**SUBJECT: RESPONSE TO THE NOD FOR THE TA-18, PRSs
 18-003 (a-d, g) IA PLAN AND REPORT**

**RESPONSES TO COMMENTS BY
NEW MEXICO ENVIRONMENT DEPARTMENT
ON INTERIM ACTION PLAN FOR PRSs 18-003(a,b,c,d, and g)
AND INTERIM ACTION REPORT FOR PRSs 18-003(a,b,c,d, and g)**

Figure A.1-1. Sampling results for PRS 18-003(a).

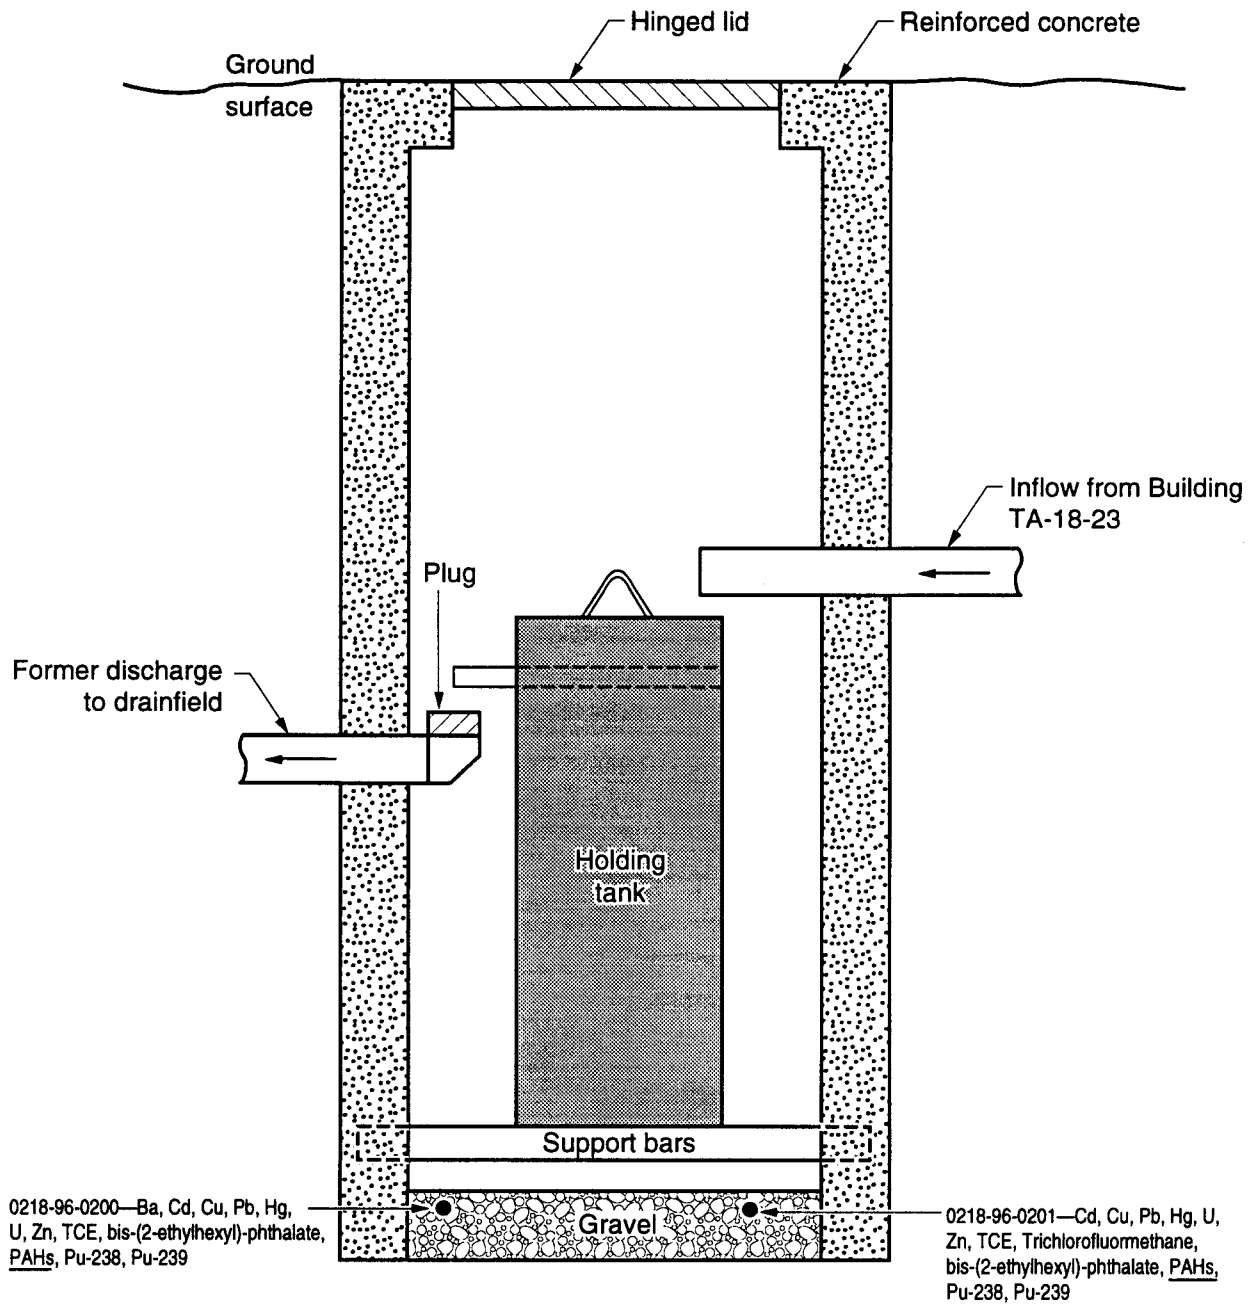
2. *Section 2.2, Operational/contamination History: The first paragraph states, "Because such discharge would reach the drainfield, water service to the building has been shut off and the catch tank's overflow line has been plugged. However, the concrete pit is open at the bottom, leaving a pathway to the soil for any leaks or spills from the tank." Please indicate how the overflow line was plugged and summarize the sampling methodology and analytical results of the concrete pit's characterization.*

3. *Section 3.0, Interim Action: The last paragraph states, "The outside surface of the catch tank at PRS 18-003(a) will be swiped to determine if alpha contamination is present indicating that an overflow may have occurred. In addition, the gravel bottom of the pit will be sampled for contamination." Please clarify how the gravel bottom of the pit was sampled and provide a table summarizing the analytical results.*

The overflow line was plugged with an expandable rubber stopper (see Figure A.1-1, Annex A). As stated in Section 3, radiological swipes were collected from the exterior of the catch tank, and samples of gravel were collected from the bottom of the pit. Annex A to these responses contains a discussion of the sampling methodology and analytical results.

Two samples were collected from the bottom of the vault. The samples were collected from 0 to 6 in. in the gravel in the bottom of the vault, which is approximately 10 ft below grade (Figure A.1-1). The samples were analyzed for total uranium, isotopic plutonium, volatile organic compounds (VOCs), semi-volatile organic compounds (SVOCs), and target analyte list metals. Low concentrations of several metals—uranium and plutonium—were detected above background. Trichloroethane and other organics were also detected. Of these, only polycyclic aromatic hydrocarbons (PAHs) were present above screening action levels (SALs). As discussed in the following sections, the reported concentrations of potential contaminants indicate that at some time during the use of the holding tank (1955 to present), some contamination was released from the tank to the vault. However, it is concluded that the concentrations of contaminants of potential concern (COPCs) in the gravel do not present unacceptable risk to human health and NFA will be proposed for this PRS.
